SERVICE BULLETIN

TR-8400

#843

SUBJECT: TR-8400 Sub-audible Encoder Installation

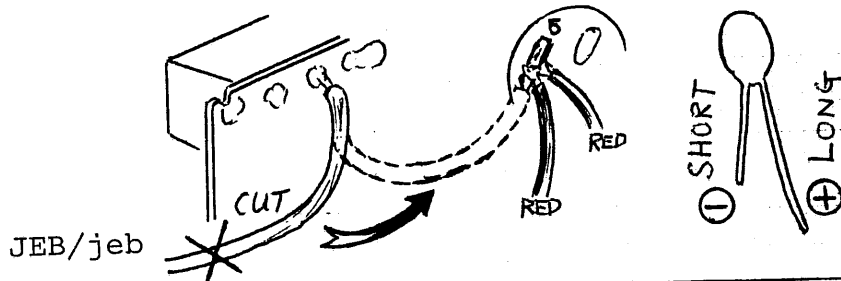
When installing a sub-audible encoder in a first-lot radio, change the Tone switch power source from the 8C (common) to the 9T (transmit) line. This will prevent the encoder from distorting the receiver when the Tone switch is ON.

1. Remove the bottom cover (2 long screws, rear, 3 short screws, front) and unplug the speaker.
2. Cut the GRAY lead to the Tone switch wiper one inch from the switch. Tape-insulate the long lead to the harness.
3. Connect the switch wiper to the Mic connector, pin 5. (See Fig. 1)
4. Install the encoder, connect the speaker, and replace the bottom cover.
